RE-909

Additional Advisory

RE-909 Additional Advisories:

v0.1E

3 - SWITCHBOARD PCB ERROR

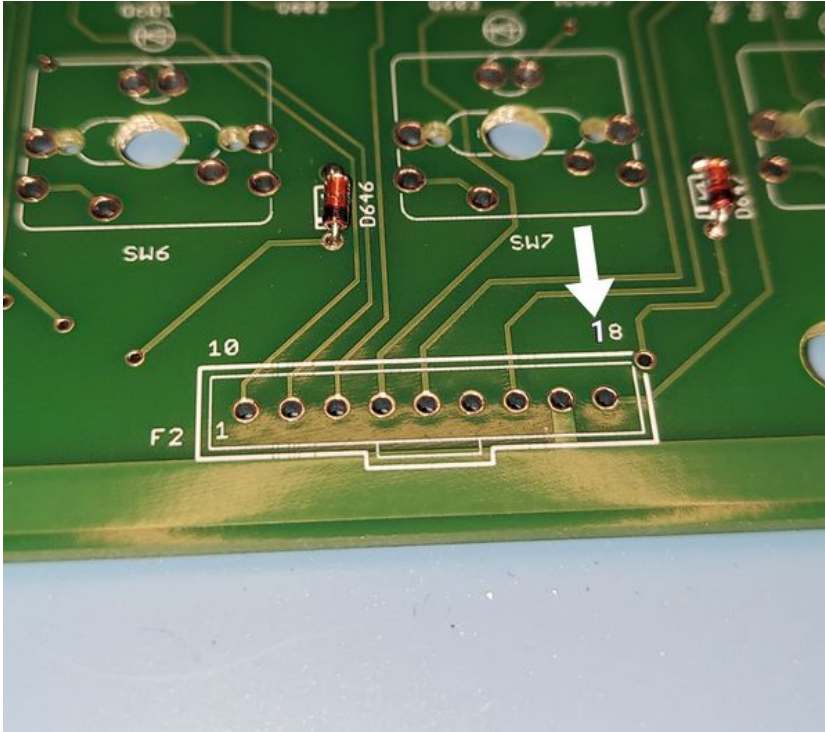
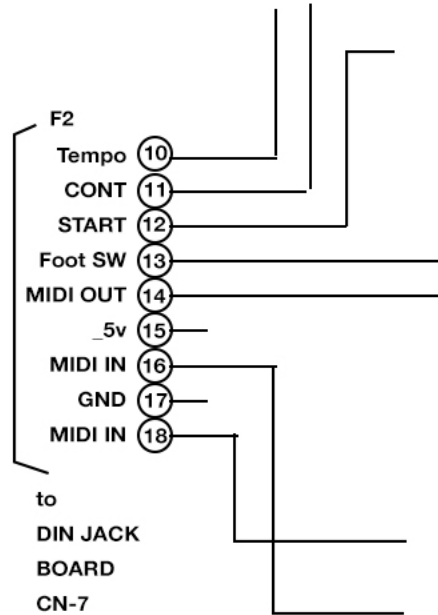
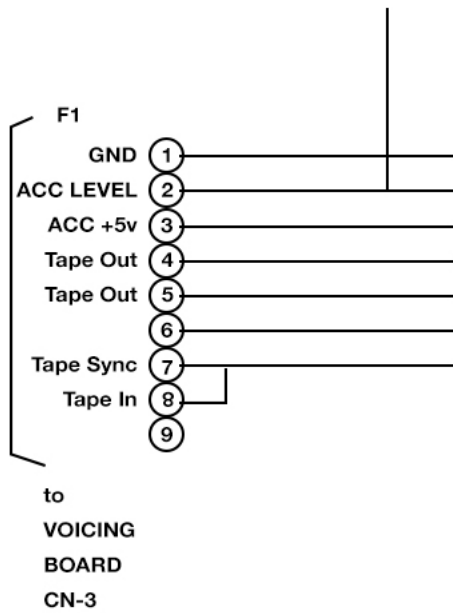
The pin numbers of the switchboard connectors were incorrect on the initial run. See the pin out/destination diagram from the service notes (above) and be sure of your pins and destinations on your switch board (below). Check twice, solder once.

3A - RE-909 Cabling Guide

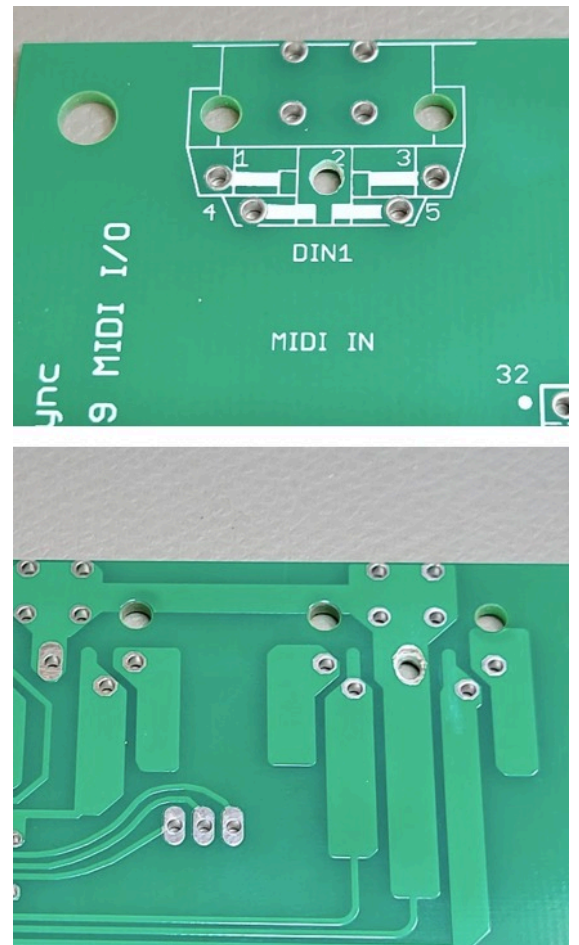
Switch Board F1 to Voicing Board CN3

1 – 29
2 – 28
3 – 27
4 – 26
5 – 25
6 – 24
7 – 23
8 – 22
9 – 21

Switch Board F2 to DIN Jack Board CN7

10 – 10
11 – 11
12 – 12
13 – 13
14 – 14
15 – 15
16 – 16
17 – 17
18 – 18

Switch Board F3 to Voicing Board CN1

19 – 1
20 – 2
21 – 3
22 – 4
23 – 5
24 – 6
25 – 7
26 – 8
27 – 9
28 – 10

|_ **Disconnect for safety PSU**

Switch Board F4 to Voicing Board CN2

29 – 11
30 – 12
31 – 13
32 – 14
33 – 15
34 – 16
35 – 17
36 – 18
37 – 19
38 – 20

5 - SD ENVELOPE FIX

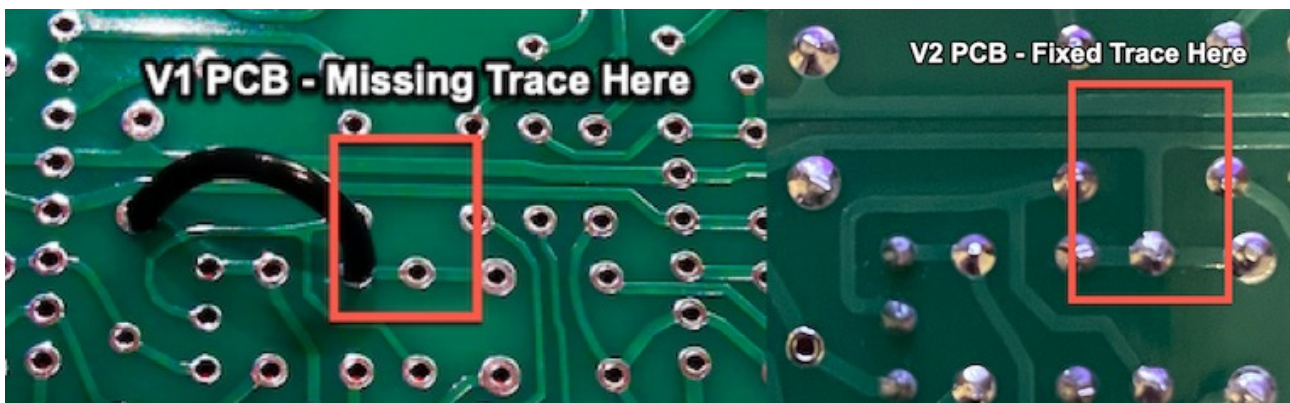
RE-909 service advisory 15-12-20

We found a minor error in the snare drum that didn't come up in testing. Its a simple fix with a single patch wire, please download v.1.7 build documentation for details.

Fixed in voice boards V2
